FALCON SERVICE BULLETIN

FALCON 900EX EASy

No 614

EDU INTERNAL BATTERY REMOVAL

Figure 1: EXTERNAL REMOVABLE BATTERY REPLACEMENT

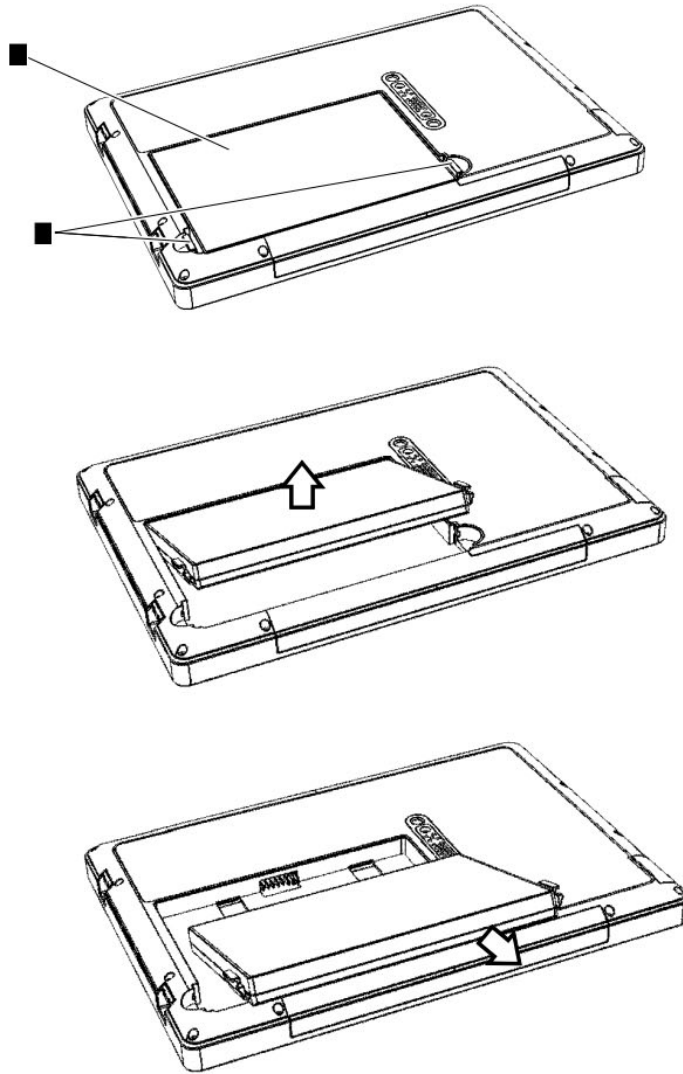
- (1) Obey the general maintenance and safety precautions ([TASK 20-00-00-910-801](#)).
- (2) Check the external removable battery for integrity (no swelling). If swelling is noticed, replace the battery :
 - Press the two clips ([1-fig. 1](#)) to unlock the battery ([2-fig. 1](#)).

- Remove the battery ([2-fig. 1](#)).
 - Install a new battery ([2-fig. 1](#)) in position.
 - Make sure that the clips ([1-fig. 1](#)) are engaged.
- (3) Get a software that can calculate CRC32 checksum (for example "7-zip File Manager").

Figure 2: BIOS CHECKSUM CALCULATION

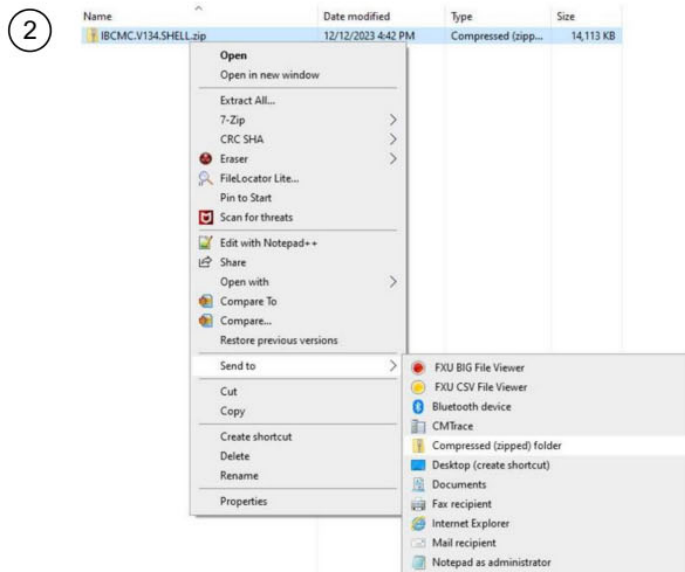
REASON: Modification of BIOS zip file CRC32 calculation.

- (3) Download the CMA-1310 AMI BIOS V134 (File name: IBCMC.V134.SHELL.zip) software from the Falcon Portal to a USB key (refer to [3.B.](#)).
- (4) Proceed to BIOS zip file CRC32 calculation (for example with "7-zip" previously got) ([fig. 2](#)) as follows:

- If the "7-Zip / CRC SHA" functionality is available, perform the following steps:
 - right click on the ".zip" file, the "CRC SHA" menu, and then the "CRC-32" option ([1-fig. 2](#)),

- check that the "CRC-32" value is "560244EA".
 - If the "7-Zip / CRC SHA" functionality is not available, perform the following steps:
 - right click on the ".zip" file, then select "Send to a compressed folder" option ([2-fig. 2](#)),

- select "Yes" to create the .zip file on the desktop,
 - right click to open the .zip file on the desktop,
 - if necessary, right click in the explorer header to activate the "CRC-32" option ([3-fig. 2](#)),

- check that the "CRC-32" value is "560244EA".
